DUKE POWER COMPANY	
MCQUIRE NUCLEAR STATION UNIT 1	
INSTRUMENT DETAIL	
NI SYSTEM FLOW ELEMENTS FOR PRE-OPERATIONAL TEST	
DESIGNED: C. J. [Signature]	DATE: 4-12-78
DRAWN: [Signature]	DATE: 4-12-78
CHECKED: [Signature]	DATE: 4-12-78
APPROVED: [Signature]	DATE: 4-12-78
DWG. NO. MC-1499-NI41	REV. 4

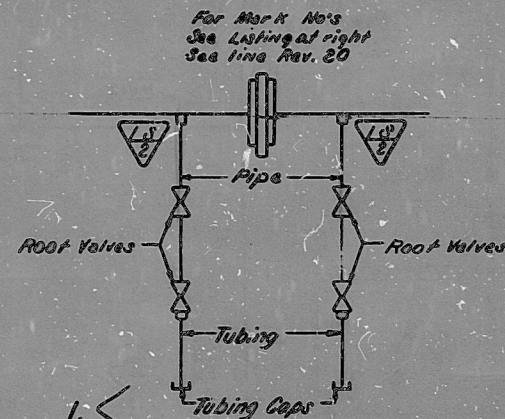
Root valve installation off INIFE1738 is unacceptable and requires support by Design Hanger Group. (Ref. construction Iso. MCFI-INIFE5020)
